3. NON MATERIAL AMENDMENTS

3.3 Basement Layout

FIG 2 _ PROPOSED _ Basement plan

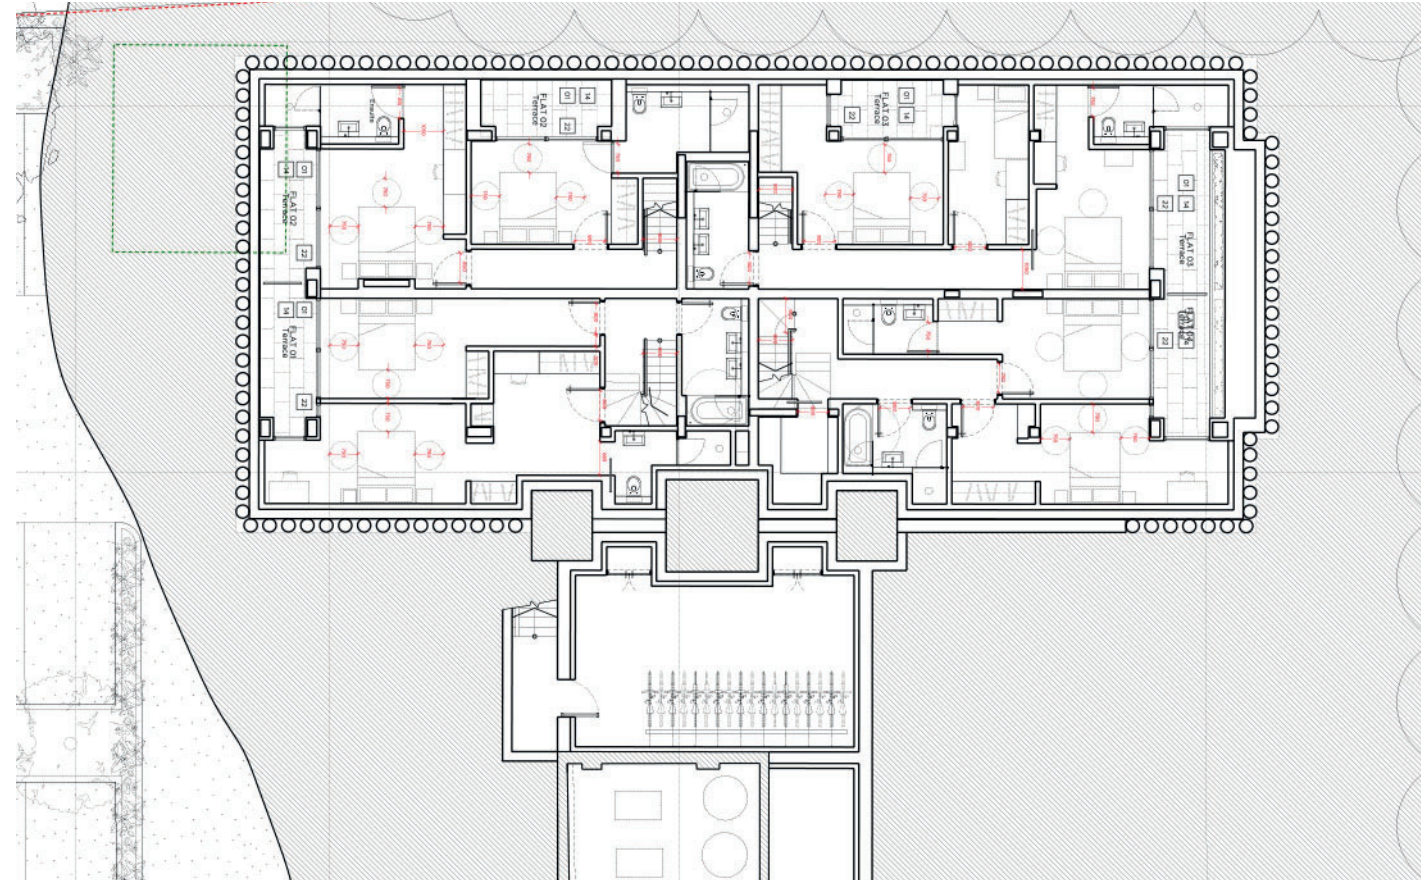
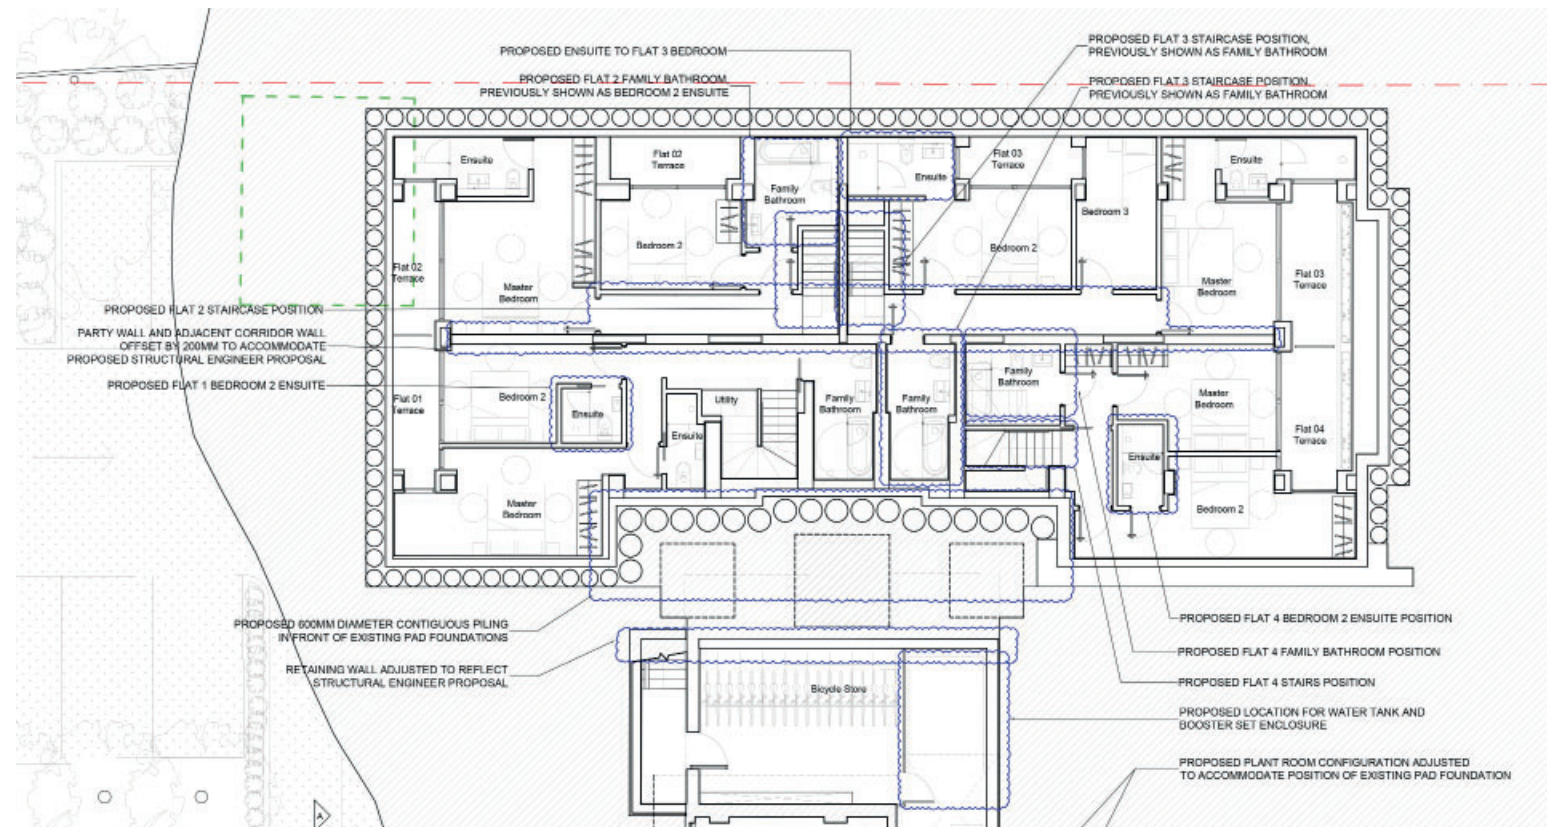
Basement layouts have been adjusted to reflect the new configuration of the foundations around the existing pads of Barrie House. The primary objective during the design process was to maintain the relationship between habitable rooms and light, fresh air, and access to the external light wells. Bedroom shape, floor area, and orientation have been maintained. Only service areas such as corridors, bathrooms, plant rooms, and staircases have been rearranged as a direct result of the structural changes to the original consented scheme.

FIG 2 _ PROPOSED _ Ground floor plan

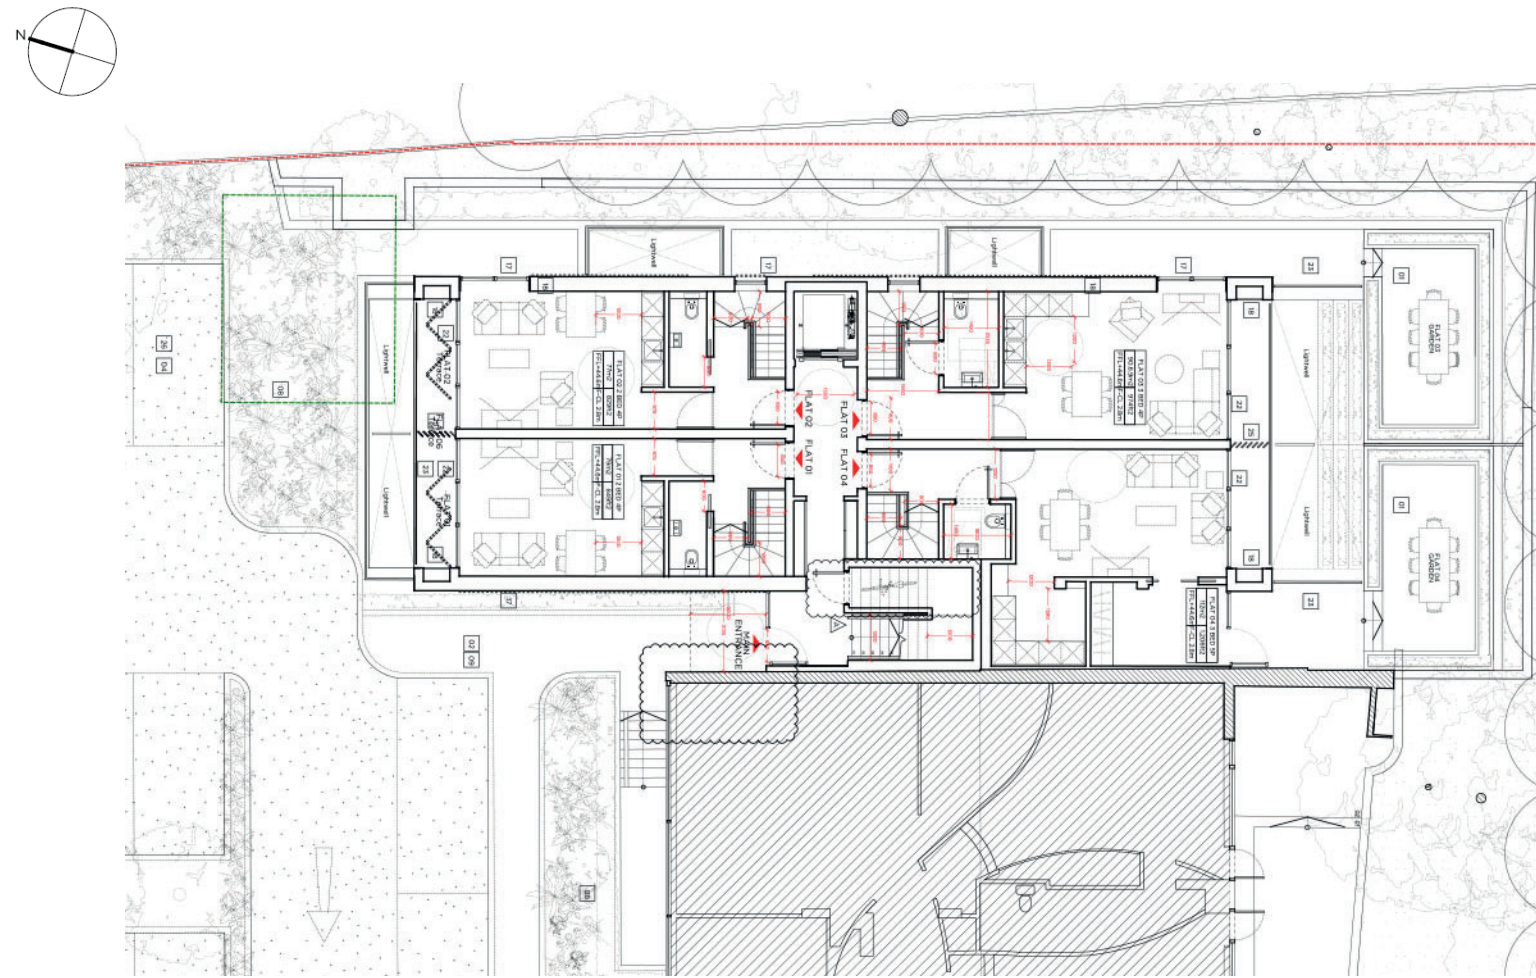
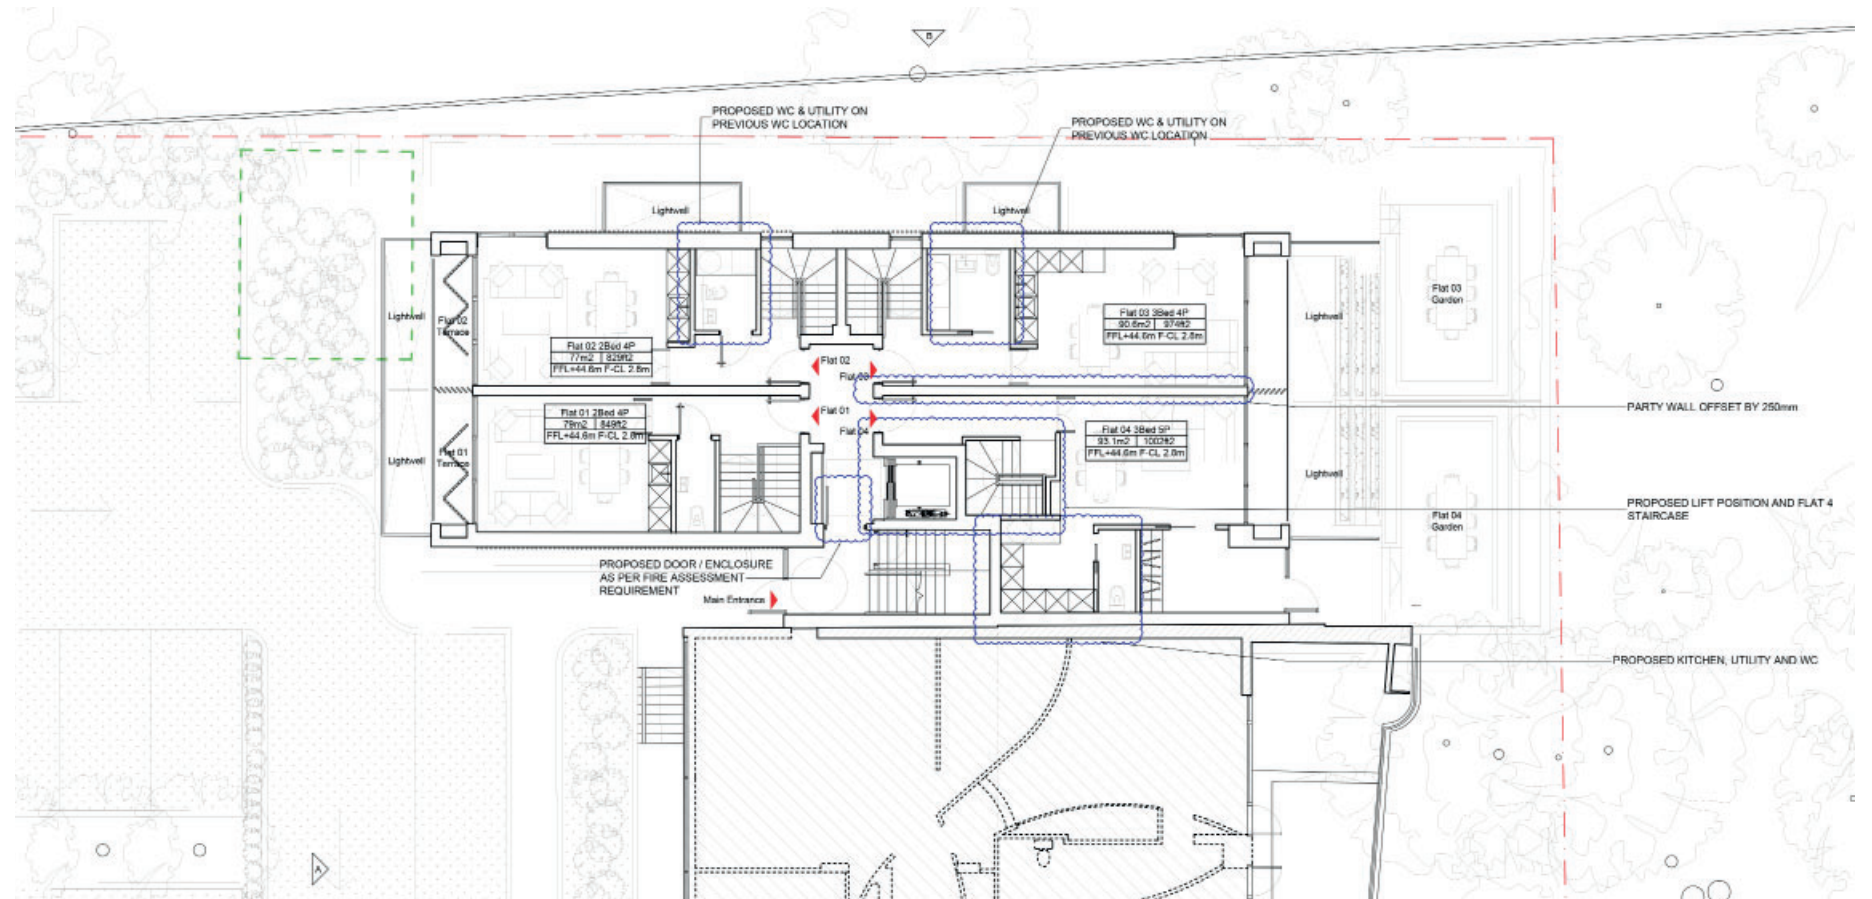
Ground floor had to be adjusted as a consequence of the change in the staircase position as annotated on Fig. 2. The same floor areas and unit mix have been maintained.

FIG 2 _ PROPOSED _ First floor plan

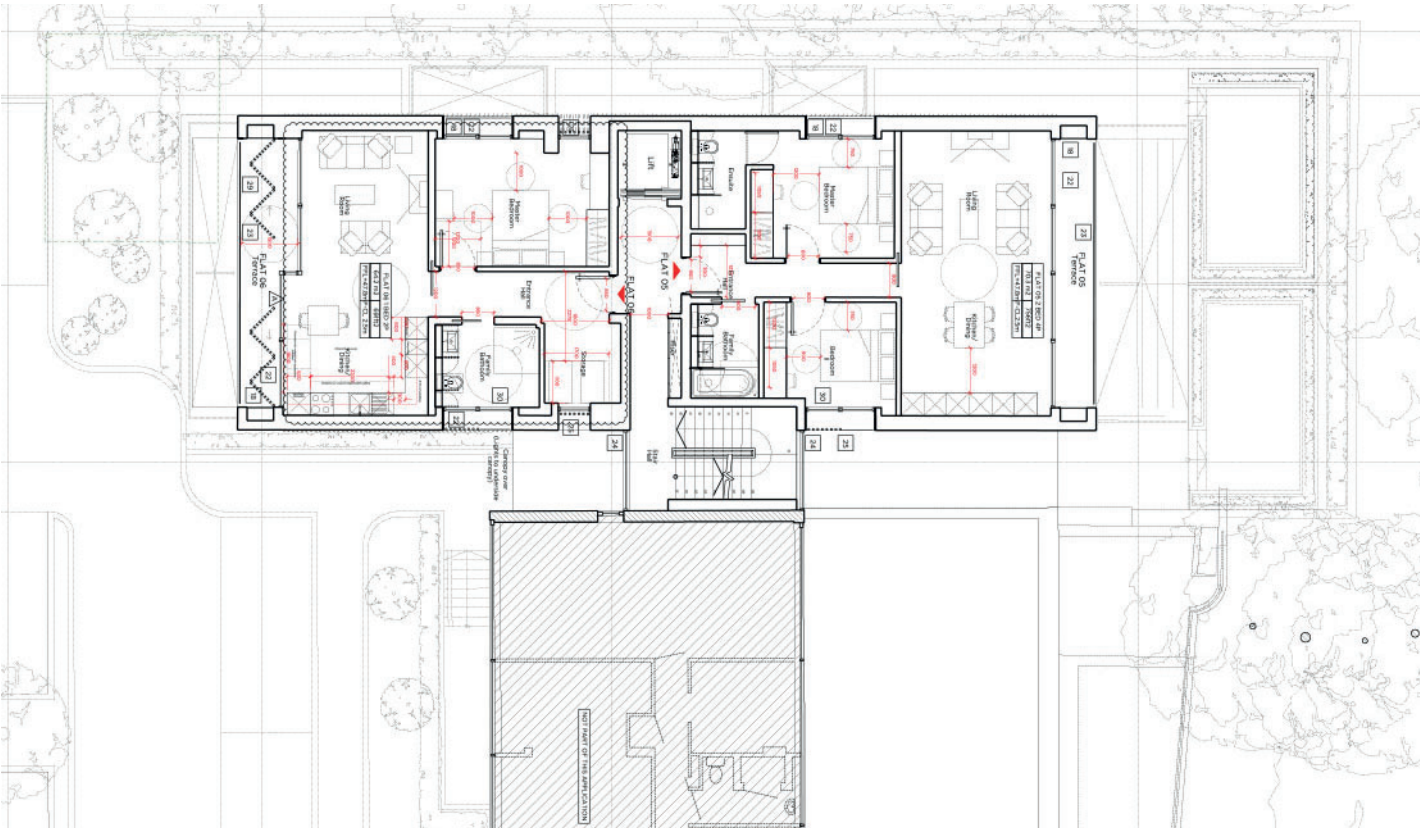
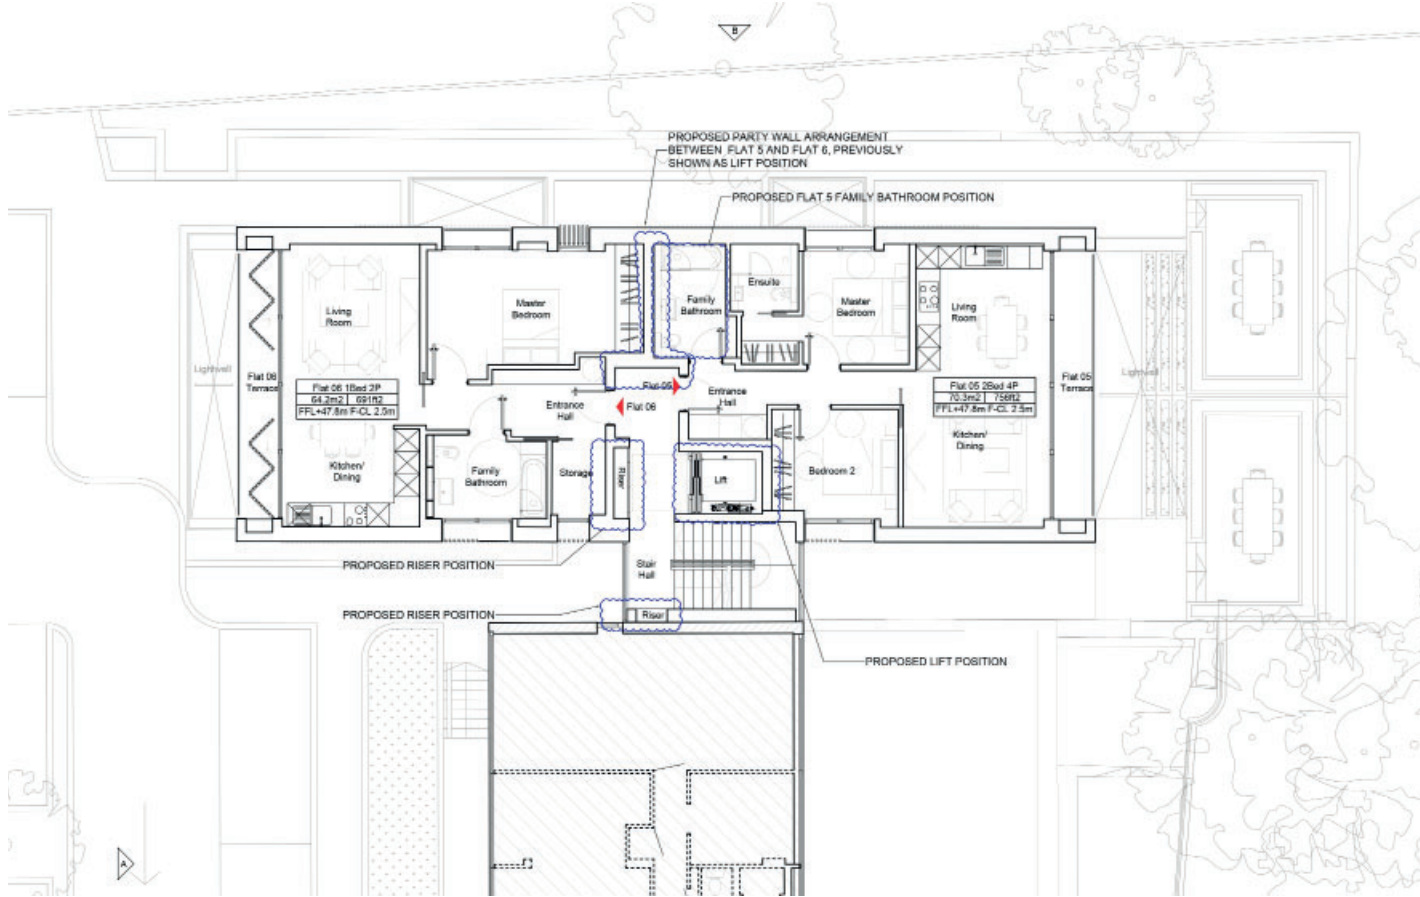
First floor layouts have been adjusted to accommodate the change to the lift position only. The changes to these floors are very localised to the party wall, riser and some family bathrooms only (see Fig. 2).

FIG 1 _ PROPOSED _ Second floor plan

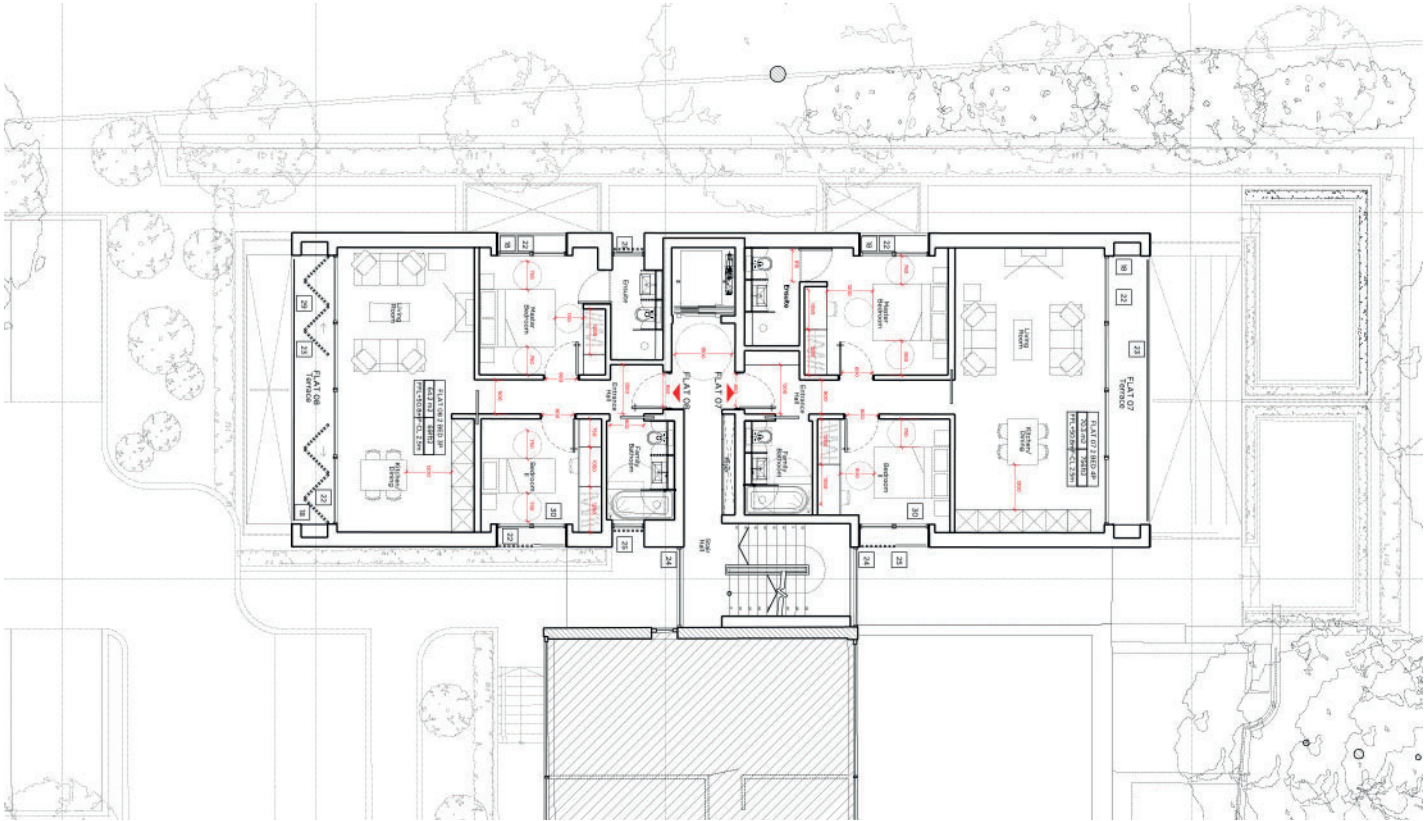
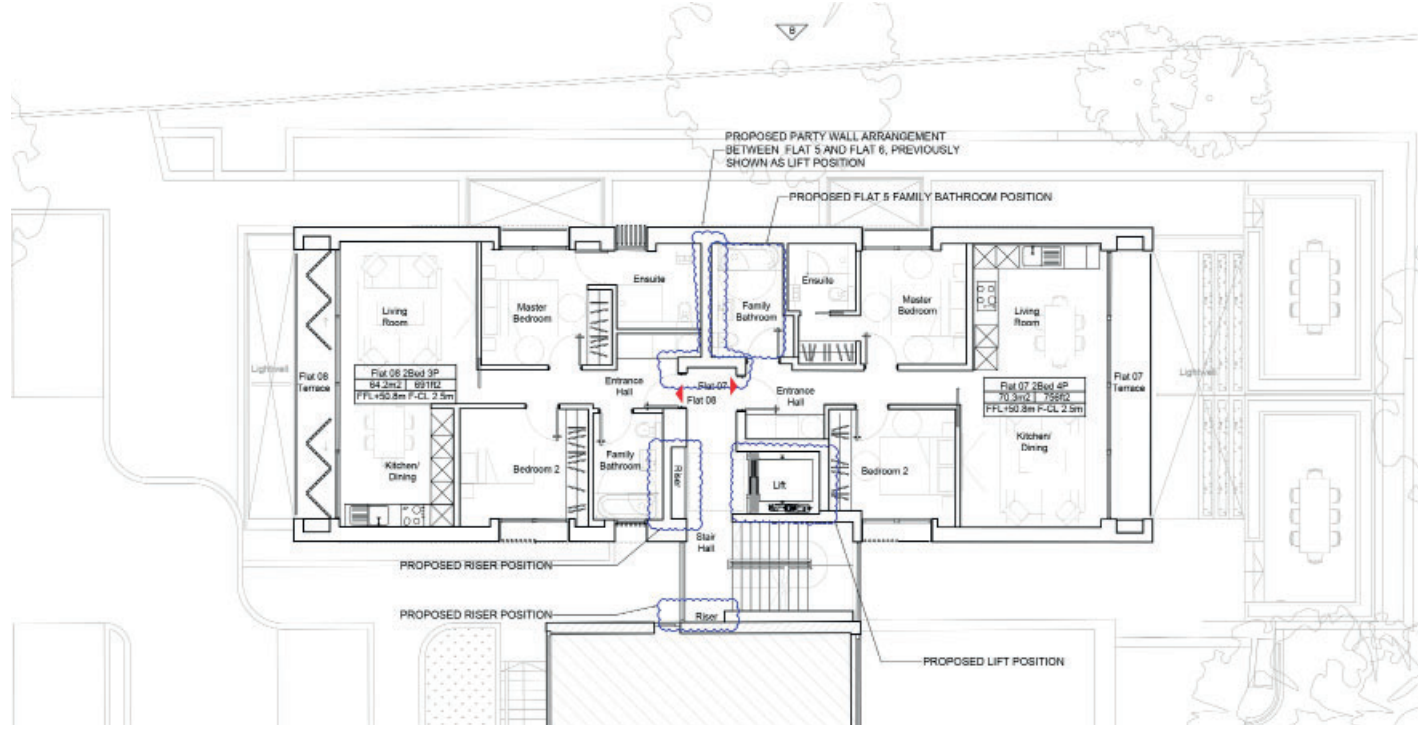
Second-floor floor layouts have been adjusted to accommodate the change to the lift position only. As for first floor layouts, the changes to these floors are very localised to the party wall, riser and some family bathrooms only (See Fig. 2).
